RE: Approval With Modifications
Request For Approval Of Process Design Changes
Western Refining Company, Southwest, Inc., Gallup Refinery
EPA ID #NMD000333211
HWB-WRG-11-003

Western Refining Southwest, Gallup Refinery is pleased to submit the following response to the above referenced letter dated December 2, 2011. The HWB comments are underlined followed by Gallup's responses.

**Wastewater Treatment Plant (WWTP)
Work Plan Flow Diagram**

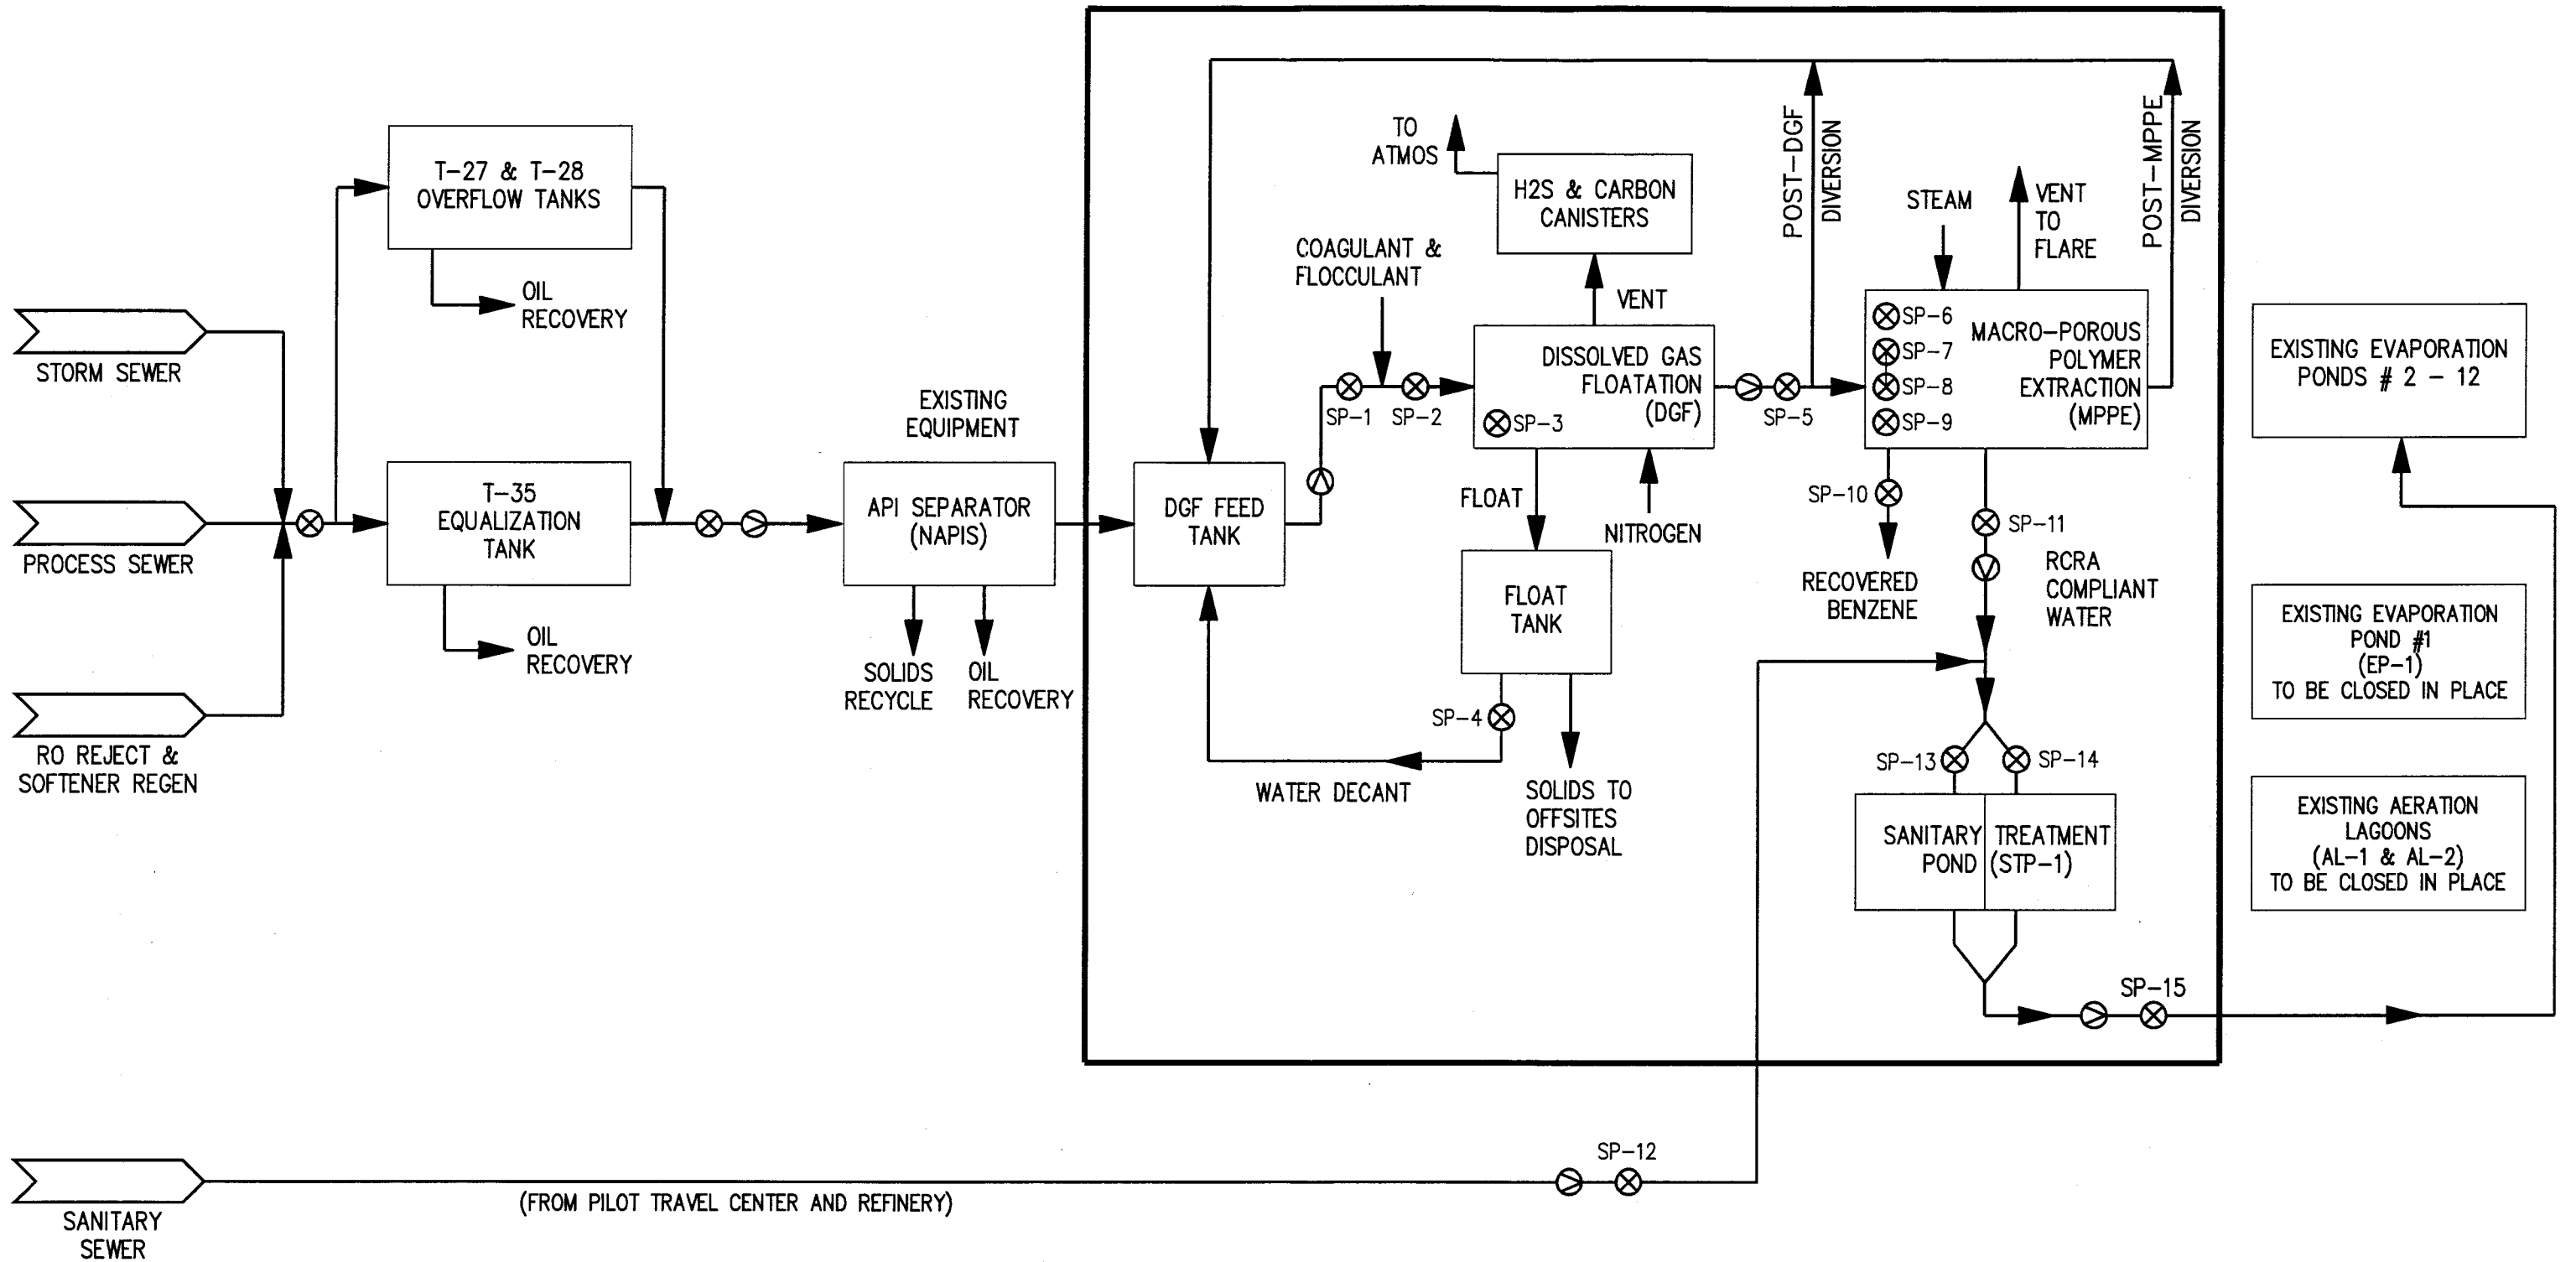
Provide a figure or design drawing depicting the sampling port design(s) per location, if different, for the WWTS monitoring system.

The drawing provided to NMED (Wastewater Treatment Plant (WWTP) Work Plan Flow Diagram) no longer shows the location of flow meters; NMED assumes that flow meters are still part of the system and the meters should be depicted in the diagram and identify the type of instrument. If this is not the case, the Permittee must explain why flow meters are no longer part of the system.

Please find Attachment 1, containing the revised Block Flow Diagram showing all of the sample points and flowmeters within the WWTS.

Please find Attachment 1, containing the revised Block Flow Diagram showing all of the sample points and flowmeters within the WWTS. For clarity, the following table gives more information:

Sample Point #	Sample Point Description
SP-1	Oil & Grease, Total Suspended Solids & pH Verification Prior to DGF unit
SP-2	Nitrogen Super-Saturation Verification Prior to DGF Unit
SP-3	Oil & Grease and Total Suspended Solid Separation Test
SP-4	DGF Float Tank Water Decant
SP-5	Oil & Grease, Total Suspended Solids & pH Verification After DGF unit
SP-6	Primary Oil & Grease, Total Suspended Solids & pH Verification After MPPE Filters
SP-7	MPPE Return Water
SP-8	Secondary Oil & Grease, Total Suspended Solids & pH Verification After MPPE Filters
SP-9	Secondary Benzene Compliance
SP-10	Recovered Benzene Quality
SP-11	Primary Benzene Compliance

SP-12	Sanitary Sewer
SP-13	Combine Benzene & Sanitary Sewers for South Bay of STP-1
SP-14	Combine Benzene & Sanitary Sewers for North Bay of STP-1
SP-15	Benzene Compliance & Treated Sanitary Quality after WWTP
